Museum of Contemporary Art

Museum of Contemporary Art
Redevelopment Project
Preferred Project Report

April 2009

Figure 1 George Street addition as originally proposed and as amended, viewed front-on

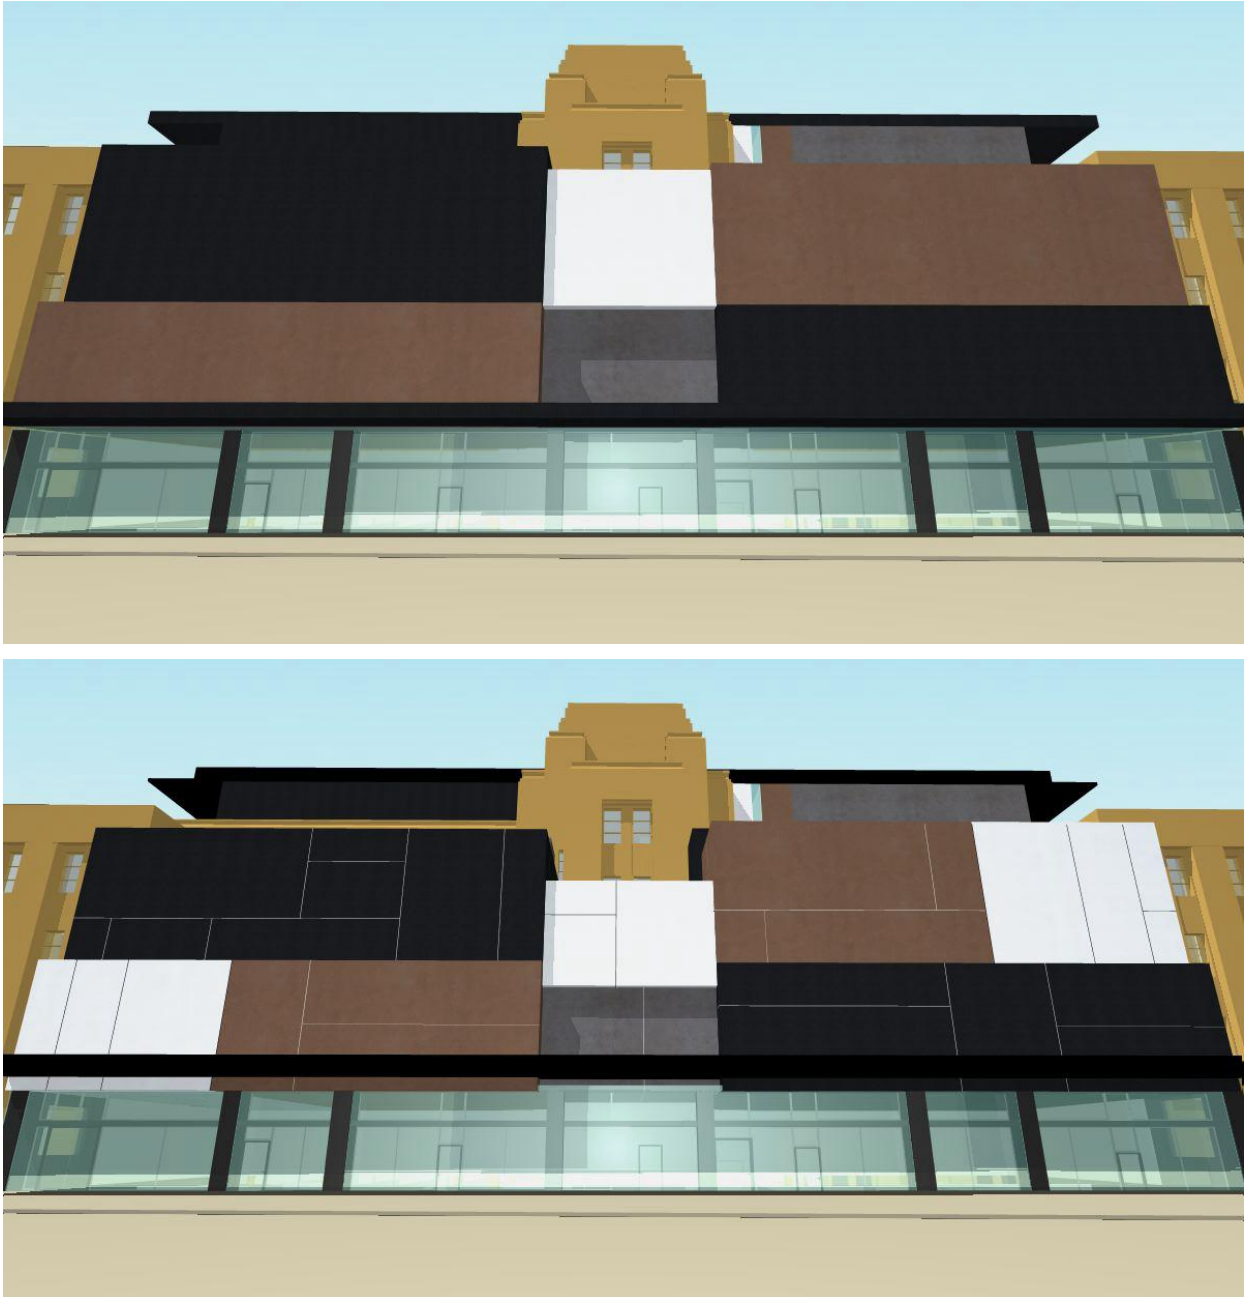
Raises concern with George Street elevation in regard to its impact on the existing building, both in terms of the visibility of existing windows and the architectural detailing and form of the (existing) building. The proposed addition will present as a solid four storey element, built to the George Street boundary of the site, and at over 40 metres in length will present as a very dominate element in the streetscape. You are requested to consider options to reduce the scale of the proposed addition to George Street, which should not be significantly above that which presently exists. Any loss of gallery floor space in this area could be replaced within other areas of building where it is proposed to provide for commercial tenants.

The proposal includes changing the facing material from the existing sandstone to a painted material to match the proposed northern extension. Although this has the potential to further obscure the original building detail as viewed from George Street, the works are supporting subject to agreement about the colour selection.

In response to the concerns raised, we have re-examined this elevation and modified the height as seen from the street and introduced more detail in the material palette to visually lessen the volume. We have reconsidered the Level 4 gallery and lowered the height of the middle section further revealing the strong central tower of the existing building and acting to further segment and lessen the scale of this elevation from the streetscape.

The northern 'block' of the Level 4 gallery has been reduced in height from RL 22.614 to RL 21.464 (reduction of 1.17 metres), the central 'block' has been reduced in height from RL 21.662 to RL 19.233 (reduction of 2.429 metres), and the southern 'block' has been reduced in height from RL 21.889 to RL 21.870 (reduction of 0.019 metres).

These modifications are shown in Figure 1, Figure 2 and Figure 3.

Figure 10 Level 6 stair as originally proposed and as amended, looking north-west

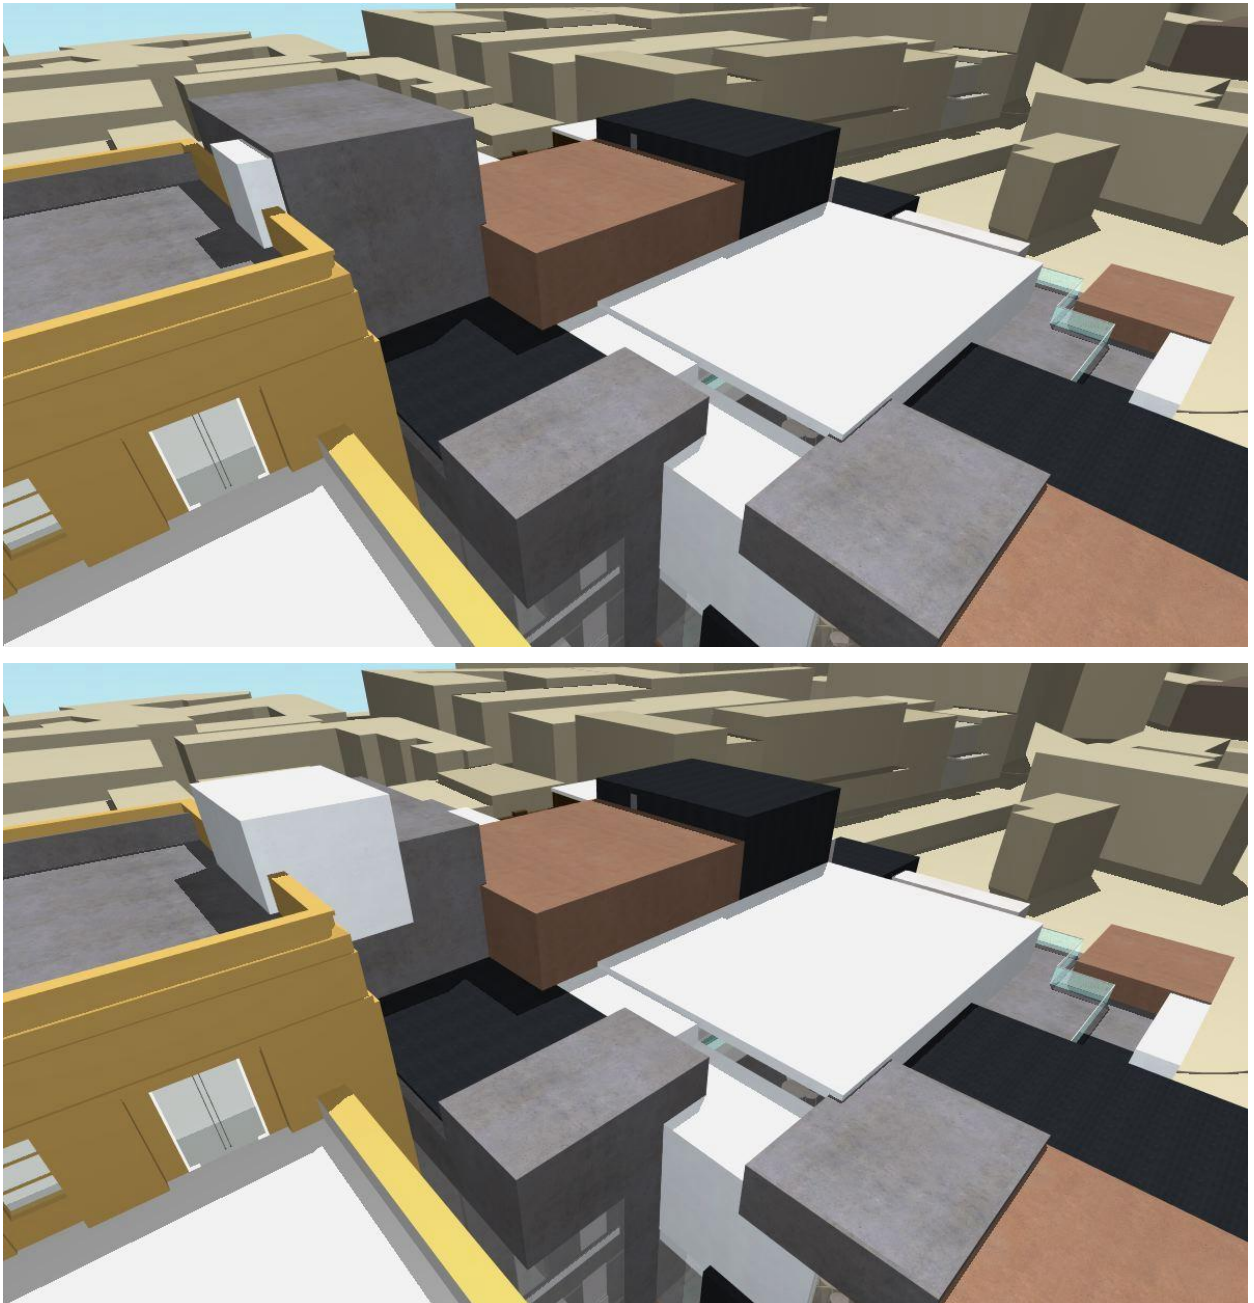
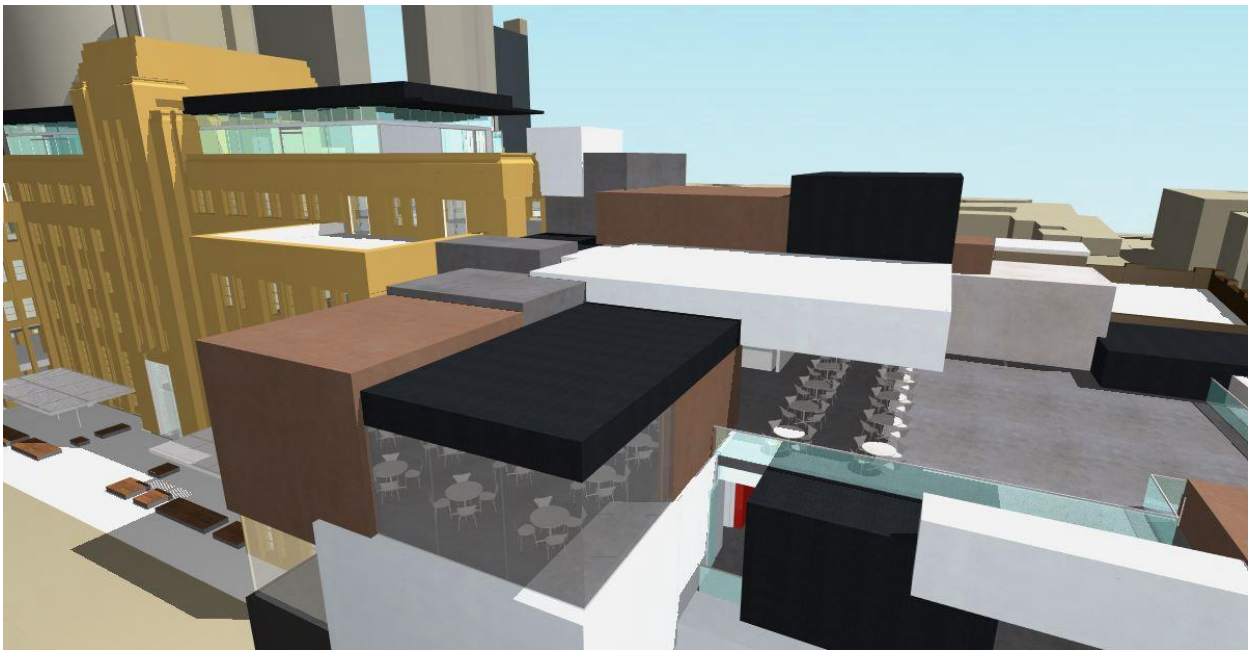
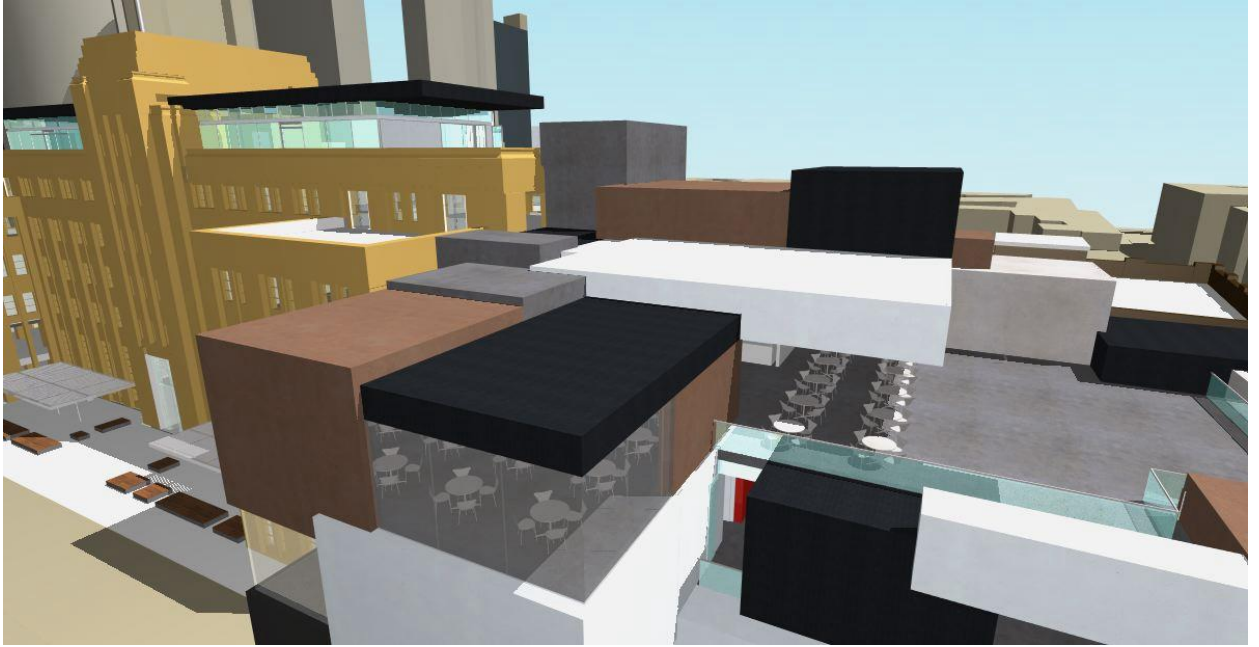
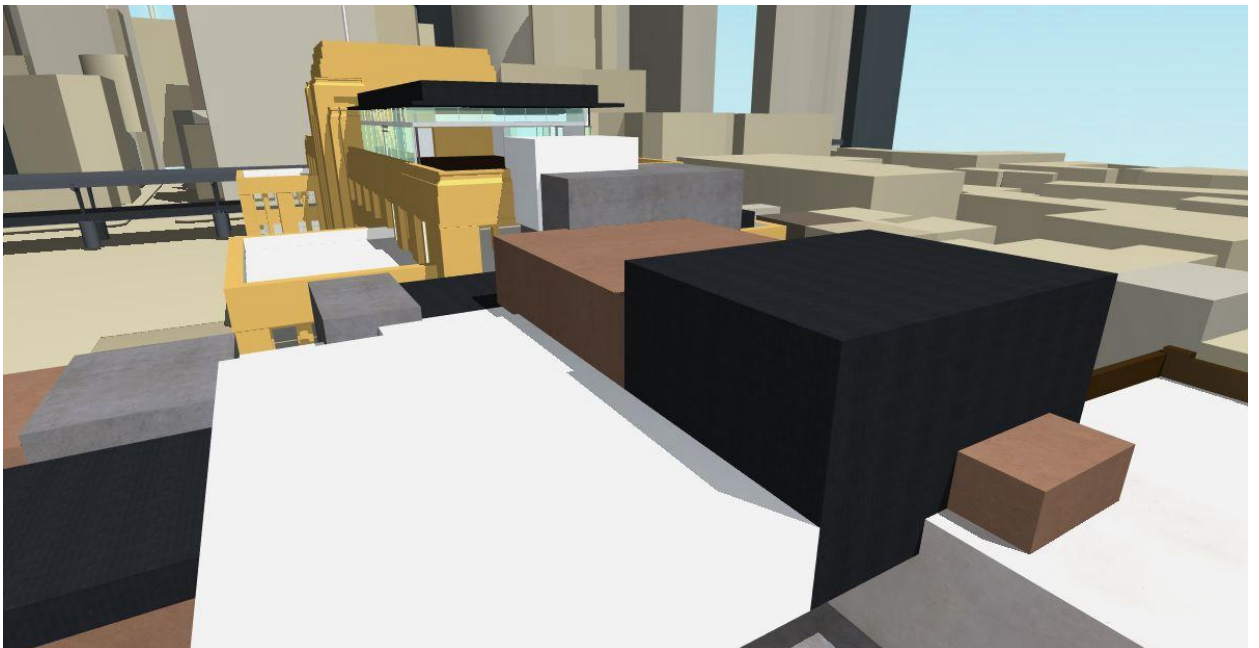
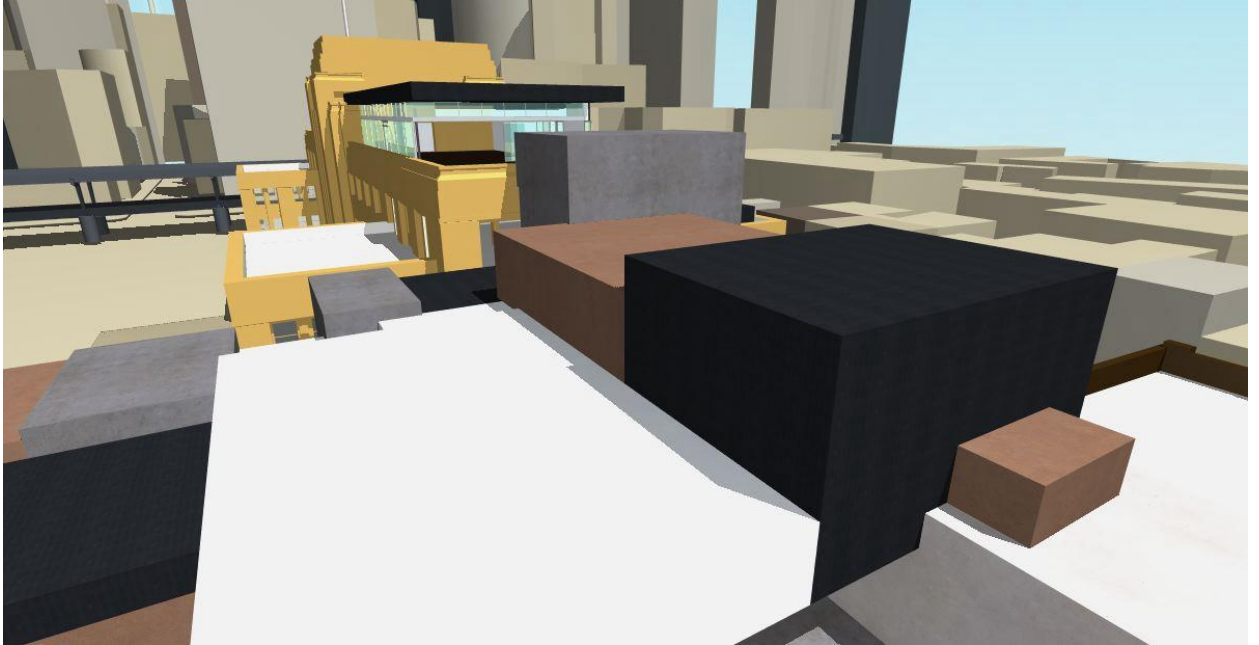
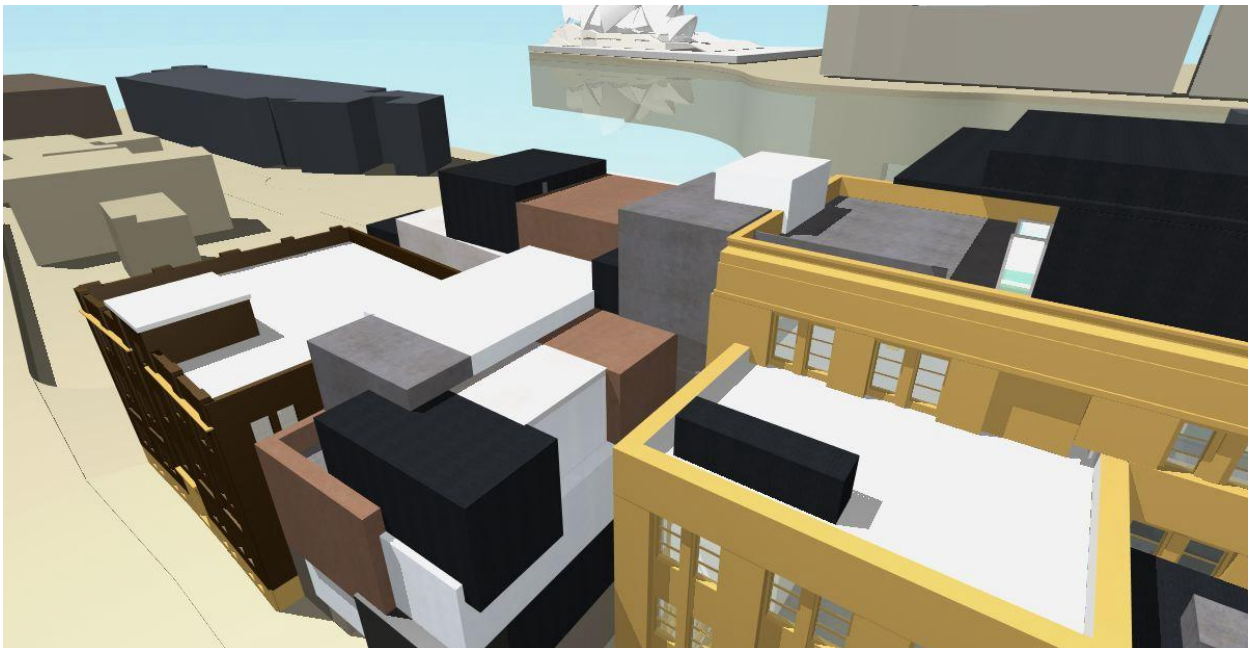
The new northern stair providing access to the existing building and new addition, including up to the new level 7 function areas and terraces, presents as a prominent building element. Combined with the plant to the roof top of the addition (level 6) these building elements of differing heights, materials and offsets do not appear to sit comfortably with the existing building or each other. It is requested to consider options for modifying or reorientate the form, scale and siting of these elements to provide a more ordered top level to the proposed building addition. This should also be done with regard to potential view impacts.

The plant area and stairway at Level 6 will result in view loss to the Harbour Rocks Hotel. This includes loss of views from 12 rooms within the hotel of the following elements (to various degrees, as supported by photomontages provided with submission):

However, we have reviewed the top of Stair 6 in the light of the concerns raised regarding the bulk and view impacts. In this regard, the plans have been amended to remove approximately three quarters of this stair from above the old building parapet. Figure 10 through to Figure 15 shows this and the associated beneficial impact on the view loss from buildings to the west.
